Request for Proposals 2022-059

Interview Room Recording System for Law Enforcement

ADDENDUM No. 2

ISSUE DATE: July 28, 2022

A1.01

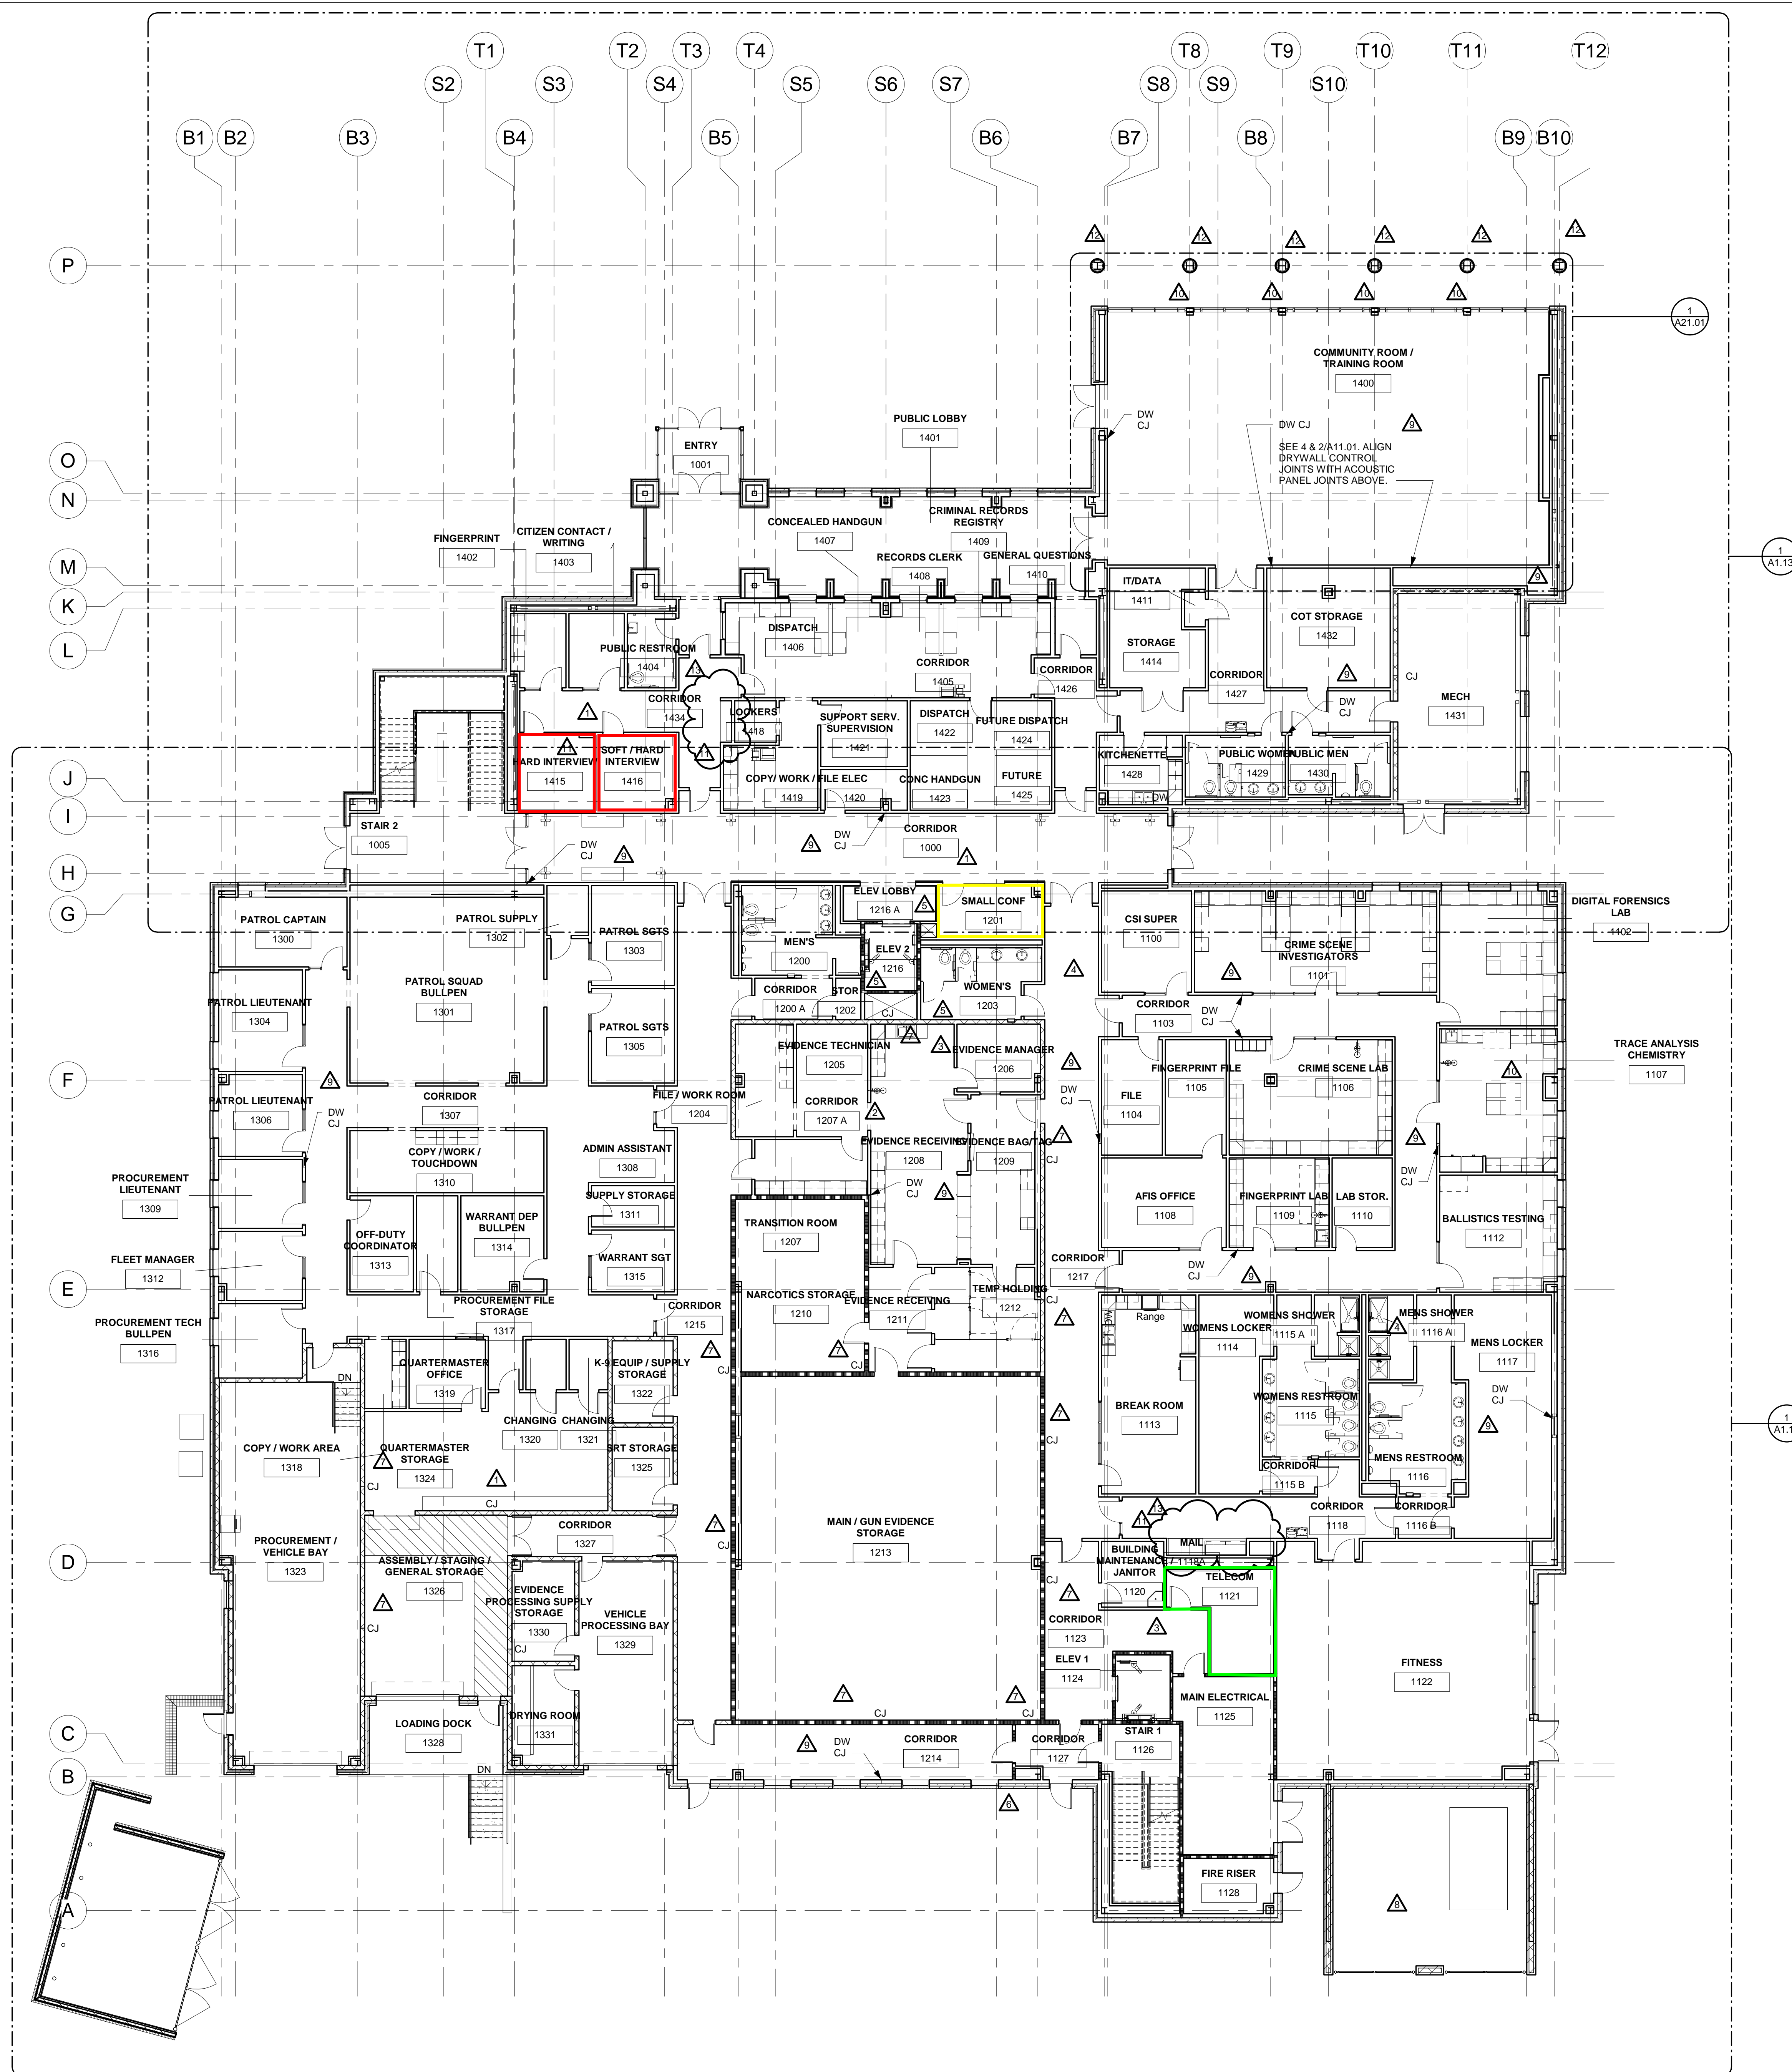
9. What is the distance between interview rooms and server room? Is it possible to provide a floor plan or schematic with interview, conference room and server room locations?

Answer: Floor plan attached. Distances unknown at this time. All wiring and networking provided by County
